3.2 MASTER RESPONSES

Master Response 1 – Introduction to the Final Environmental Impact Report and Master Responses.

Figure 3.2-1 Project Impacts to Vegetation Habitats

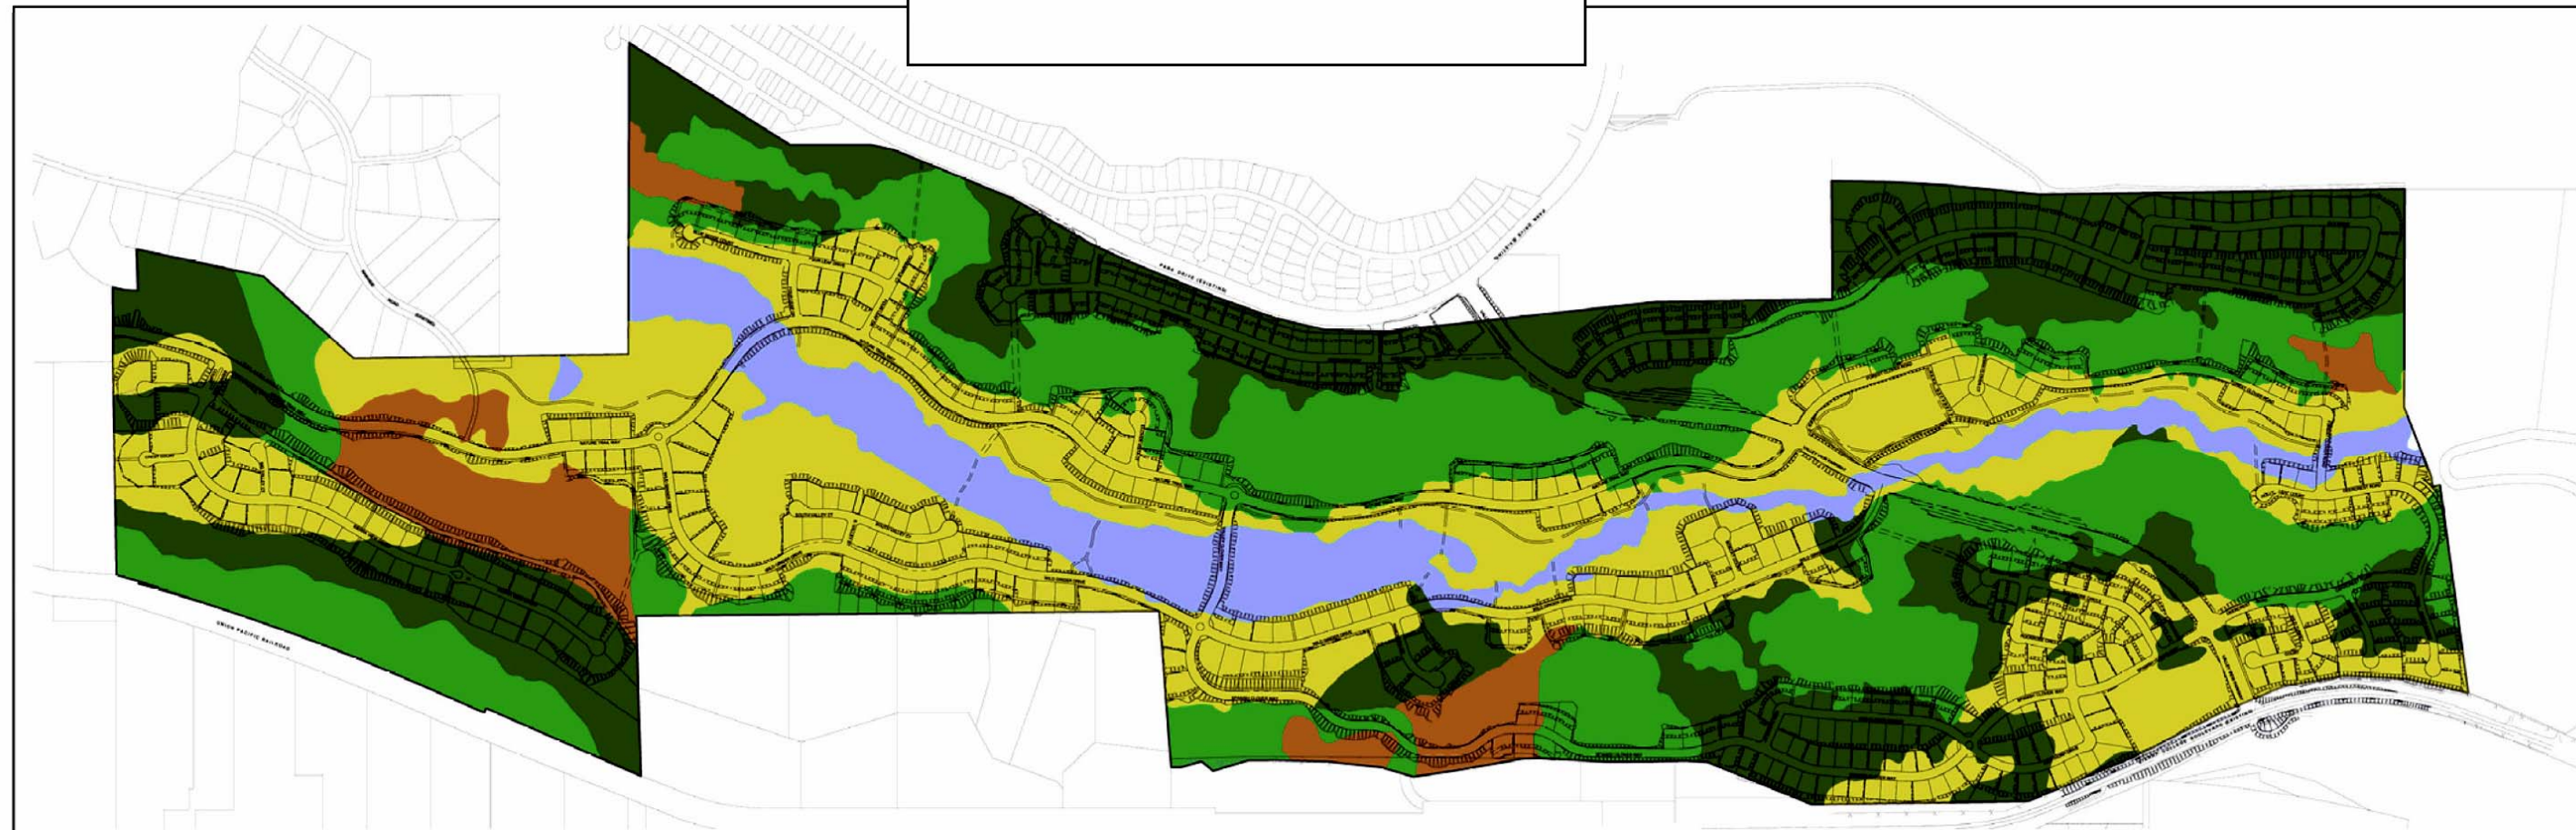
The Figure 3.2-1 (habitat map) indicates that 33 percent (205 acres) of the 622-acre project area is covered by grasslands, 5 percent (33 acres) by oak woodlands, 27 percent by foothill mixed woodlands (169 acres), 27 percent (166 acres) by oak savannah, and 8 percent (50 acres) by riparian hardwoods. A total of 3 percent (22 acres) of the project area (generally within annual grassland habitat) has been identified as seasonal wetlands.

The proposed project will result in the loss of exactly one half (321 acres) of this existing natural habitat, including: 144 acres (70 percent) of existing grassland habitat, 9 acres (27 percent) of existing oak woodland, 48 acres (28 percent) of existing foothill woodland, 112 acres (67 percent) of existing oak savannah, and 7 acres (14 percent) of existing riparian hardwood habitat. Conversely, the project will preserve 61 acres (30 percent) of grassland habitat, 24 (73 percent) acres of oak woodland, 121 acres (72 percent) of foothill woodland, 53 (32 percent) acres of oak savannah, and 43 acres (86 percent) of riparian hardwood habitat.

While the acreages of natural habitats preserved by the proposed project is significant and laudatory, it is the spatial distribution of these remaining natural habitats within the proposed residential landscape that presents a significant ecological impact, based on the above discussion of habitat fragmentation and its effect on wildlife movements. For some species, such as resident deer, birds, and other mobile (and more human-tolerant) species, the preserved habitats will provide some available habitat for movement, foraging, shelter, and even nesting/breeding. However, for other, less mobile or more disturbance-sensitive species, the construction of a residential subdivision in the middle of this valley will effectively cut off movement through the valley and limit these species’ historic ranges to the project’s northern terminus.

Figure 3-2-2
 Conceptual Slope Drainage with "Bubbler"
 Manhole Outlet

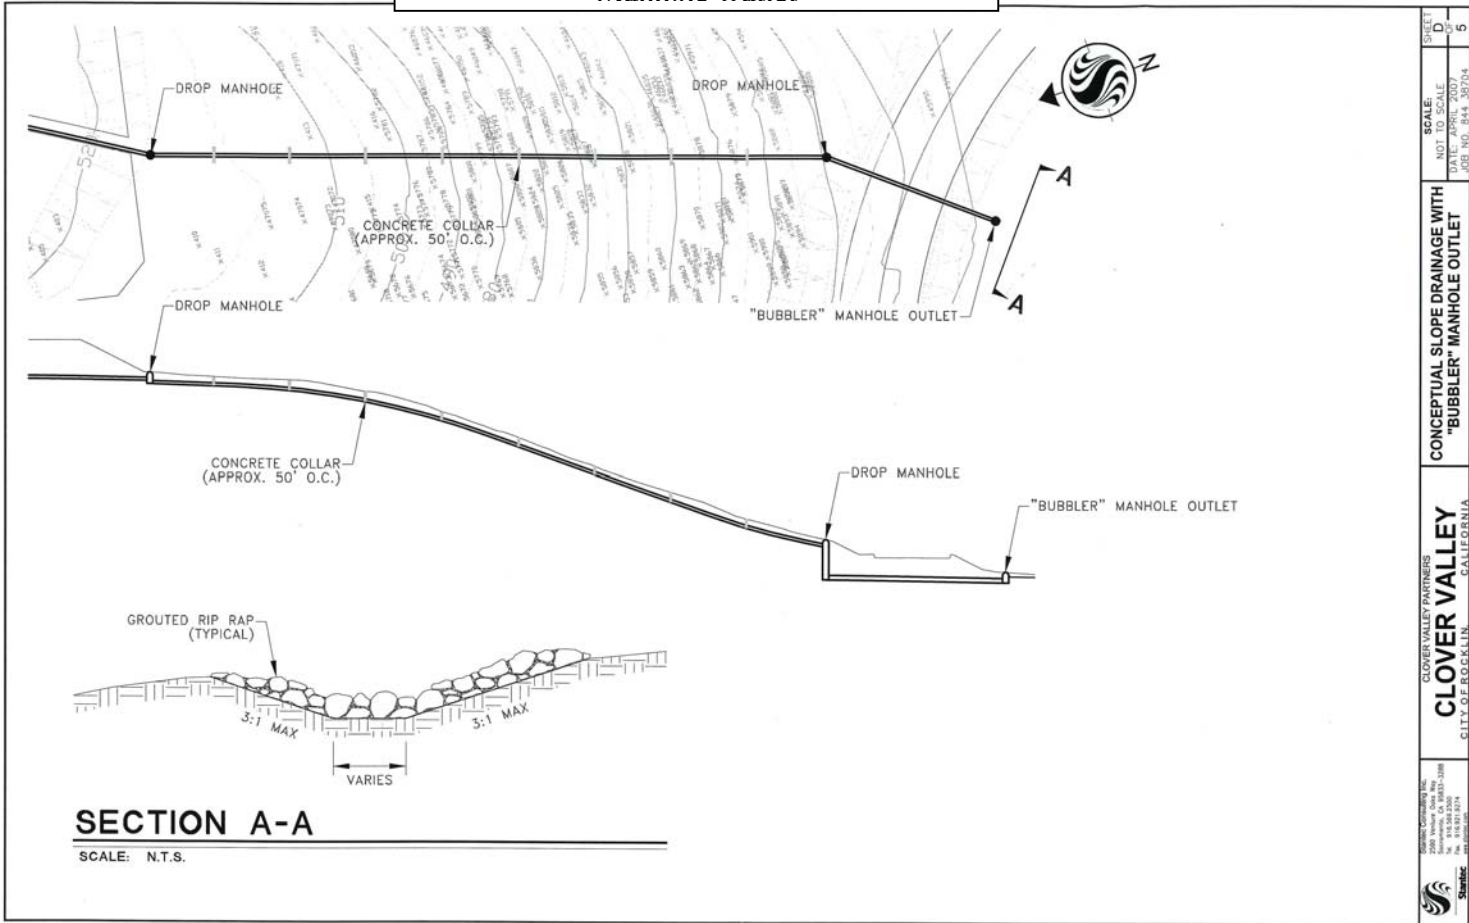
The pipe flow option would address energy dissipation through the use of vertical drops at the uphill and downhill locations. Additionally, the terminus of the pipe system at the valley floor would use a bubble up type manhole structure to further retard velocity prior to discharge into overland swales toward the creek. The amount of vertical fall is estimated at 3-4 feet at the uphill location and upwards of 10-12 feet at the downhill location (See Figure 3.2-2).
